UNITED STATES PATENT AND TRADEMARK OFFICE

APPLICATION NO.	FILING DATE	FIRST NAMED INVENTOR	ATTORNEY DOCKET NO.	CONFIRMATION NO.
10/718,425	11/20/2003	Steven Ryals	BE1-0031US	9644

DETAILED ACTION

Larsen US-5,314,160

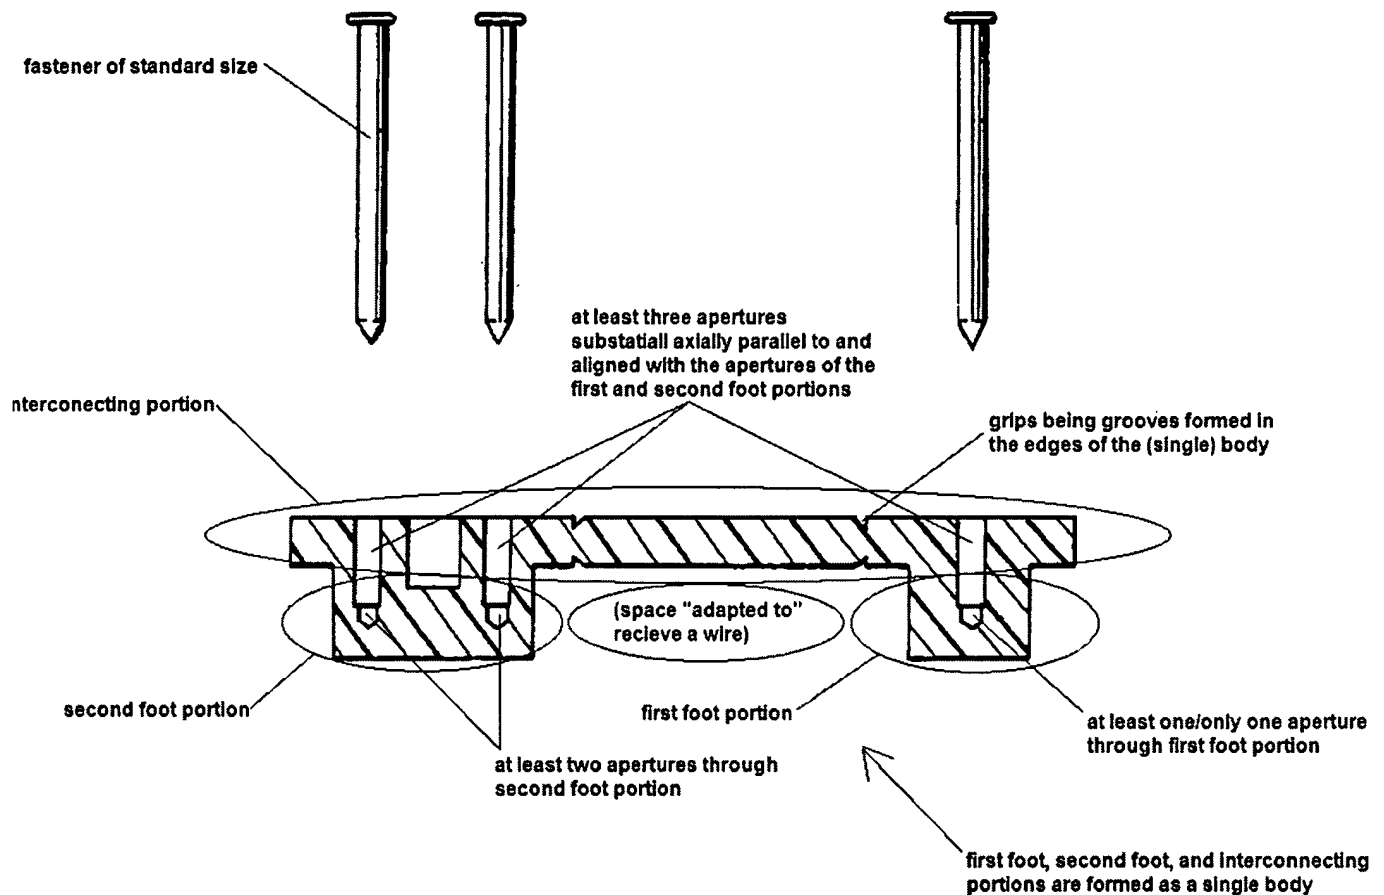
[8] Claims 9-14 are rejected under 35 U.S.C. 102(b) as being anticipated by Larsen US-5,314,160.

In short, Larsen teaches an apparatus having a body comprising a first foot portion (10) having at least one or only one aperture (38), a second foot portion (12) having at least two apertures (18, 20, 46), and an interconnecting portion (14, 23, 34, 54) that shares at least three apertures which are "axially parallel to and aligned with the apertures of the first (10) and second (12) foot portions"

Ruehl US-4,582,288

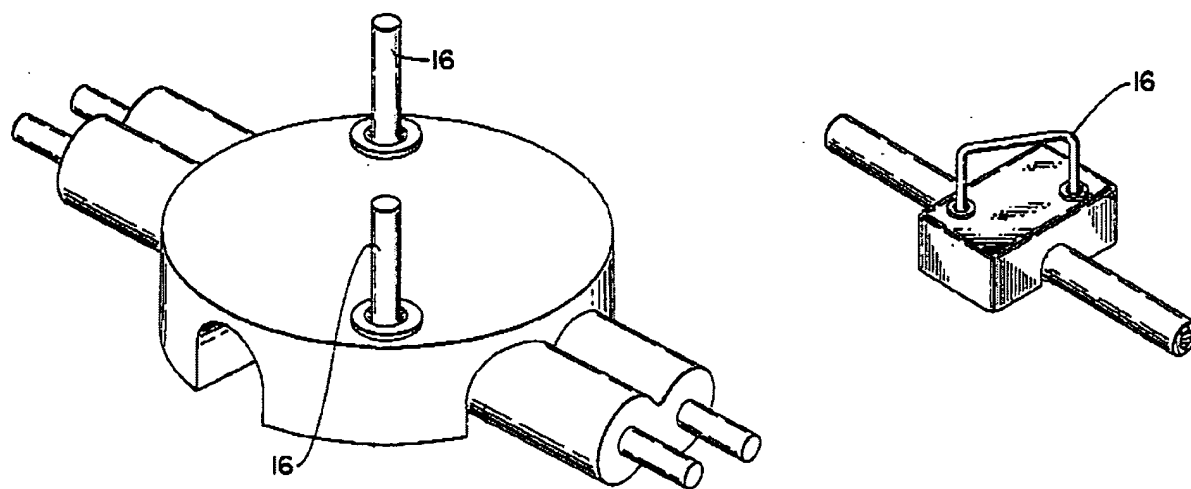
In short, Larsen teaches an apparatus having each and every limitation of claims 17 and 23-25 as discussed above, and broadly and openly states that the apertures are "complimentary to *fastening elements*, which *may* be case-hardened nails"; however, Larsen fails to disclose specifically, staples as the fastening element(s).

Ruehl suggests substituting nails for staples in an apparatus having two foot portions, an interconnecting portion, and a passage, said apparatus being adapted to receive and retain a wire.

Therefore, at the time of invention, it would have been obvious to one of ordinary skill in the art, to modify the at least one fastener taught by Larsen, to comprise a staple as suggested by Ruehl, since Ruehl establishes that a staple is an art-recognized equivalent to a nail, especially in wire protectors and retainers. Moreover, it would be advantageous to employ a staple over a nail, in order to reduce the number of working parts used to fasten the apparatus to the mounting structure.
